# Dugg Hill Estates

Woodstock, Connecticut

**Review Date:** JANUARY 20, 1987

ENVIRONMENTAL REVIEW TEAM REPORT

SOIL MAP

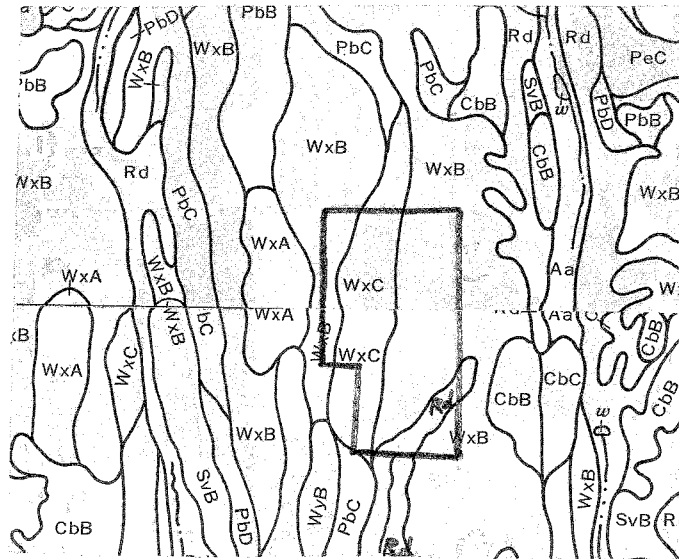
THE ATTACHED SOIL MAP, A COMPOSITE OF SOIL SURVEY SHEETS NUMBER 2 AND NUMBER 7 FROM THE WINDHAM COUNTY SOIL SURVEY REPORT, SHOW THE APPROXIMATE AREAS OF SOILS OVER THIS PARCEL. THE MORE DETAILED SOIL MAP SUPPLIED BY THE PROJECT ENGINEER WAS MADE BY A CONSULTING SOIL SCIENTIST AND WILL SHOW AREAS OF ALLOWABLE SOIL INCLUSIONS AS DESCRIBED IN THE ENCLOSED DESCRIPTION OF EACH SOIL DELINEATION. THIS DETAILED SOIL MAP HAS BEEN SUPERIMPOSED ON THE SUBDIVISION PLOT PLAN WITH BOUNDARIES OF SOIL INDICATED AS REGULATED INLAND-WETLANDS SURVEYED FROM ON-SITE FIELD MARKERS.

ADDITIONAL CONCERNS ARE THE THREE (3) LOTS PROPOSED ON THE SOUTH END OF THE PARCEL - LOTS 1, 2 AND 3. BECAUSE OF THEIR PROXIMITY TO THE HEAD WATERS OF MAY BROOK, A MAJOR TRIBUTARY IN EAST WOODSTOCK, THE TOWN MAY WANT TO CONSIDER ASKING THE ENGINEER AND DEVELOPER TO REDESIGN THE PLAN SO THAT NONE OF THE WETLAND SOILS WILL BE DISTURBED IN THIS AREA. CURRENTLY, A DRIVE IS PLANNED THROUGH THE LARGER WETLAND SOIL AREA.

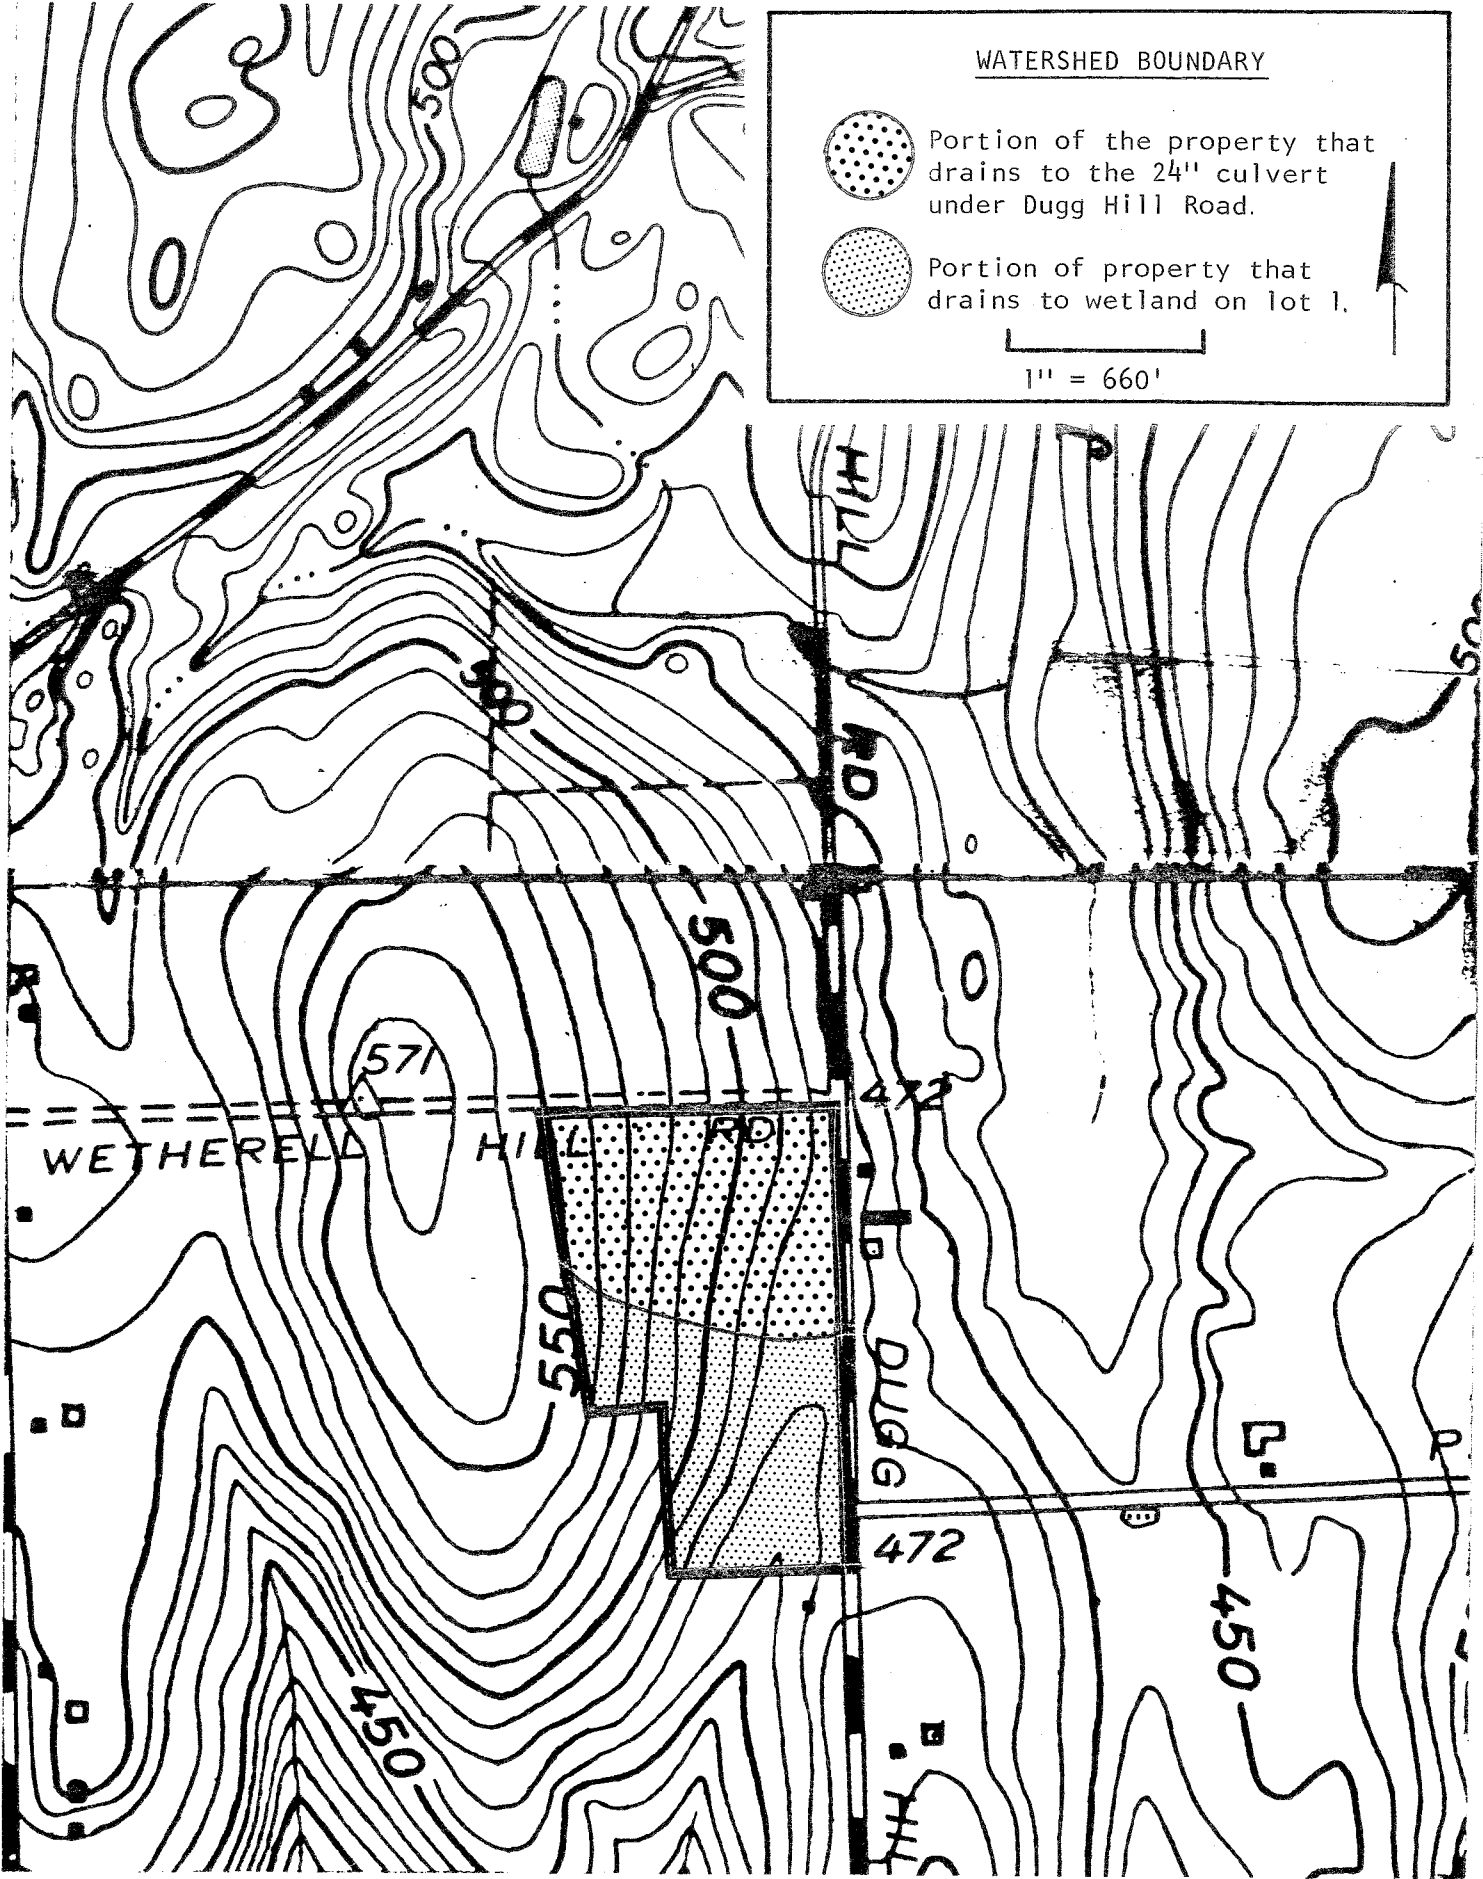
PRIOR TO THE PLACEMENT OF A 24" CONCRETE PIPE BENEATH DUGG HILL ROAD IN FRONT OF LOT 6, IT APPEARS THAT MOST OF THE ± 30 ACRE SITE DRAINED TO THE WETLAND AREA AT THE SOUTHERN LIMITS (LOTS 1 AND 2). THIS WETLAND FORMS THE HEADWATER REGION FOR MAY BROOK. THE PLACEMENT OF THE 24 INCH CONCRETE PIPE NOW INTERCEPTS SURFACE WATER FROM THE NORTHERN HALF OF THE SITE AND ROUTES IT TO THE EASTSIDE OF DUGG HILL ROAD. IT ULTIMATELY EMPTIES TO A WETLAND AREA BEHIND MONTOWESE FARMS, WHICH FORMS THE HEADWATER REGION FOR JORDAN BROOK.

CONSIDERATION BE GIVEN TO MEASURES THAT WOULD MITIGATE THE EFFECTS OF THESE INCREASES (E.G., A STORM WATER DETENTION BASIN). AS MENTIONED EARLIER, DRAINAGE ON THE SITE IS DIVIDED BETWEEN TWO (2) SUBWATERSHED AREAS. IT IS ESTIMATED THAT A LITTLE OVER 60% OF THE LOTS WOULD DRAIN TO THE 24" PIPE IN FRONT OF LOT 6. THE OUTLET STREAM FOR THE CULVERT ROUTES THE WATER TO A WETLAND ABOUT 1,000 FEET EAST OF THE PROPERTY. THE REMAINDER OF THE LOTS ON THE SITE DRAIN TO THE WETLAND AT THE SOUTHERN BORDER OF THE SITE. BOTH WETLAND AREAS HAVE THE ABILITY TO NATURALLY DETAIN THE POST-DEVELOPMENT RUNOFF FLOWS FROM THE SITE DURING RAINY PERIODS. IN ADDITION, THE OVERALL DENSITY IN EACH SUBWATERSHED IS RELATIVELY LOW. THEREFORE, IT SEEMS LIKELY THAT ANY PEAK FLOWS WOULD BE SMALL. UNDER THESE CIRCUMSTANCES, RUNOFF RETENTION DOES NOT SEEM NECESSARY. HOWEVER, A CLOSE LOOK AT THE 24" PIPE BY THE PROJECT ENGINEER IS WARRANTED. PRE AND POST-DEVELOPMENT RUNOFF CALCULATIONS SHOULD BE CALCULATED BY THE PROJECT ENGINEER TO ASSURE THAT FLOODING CONDITIONS DO NOT OCCUR AT THIS POINT.
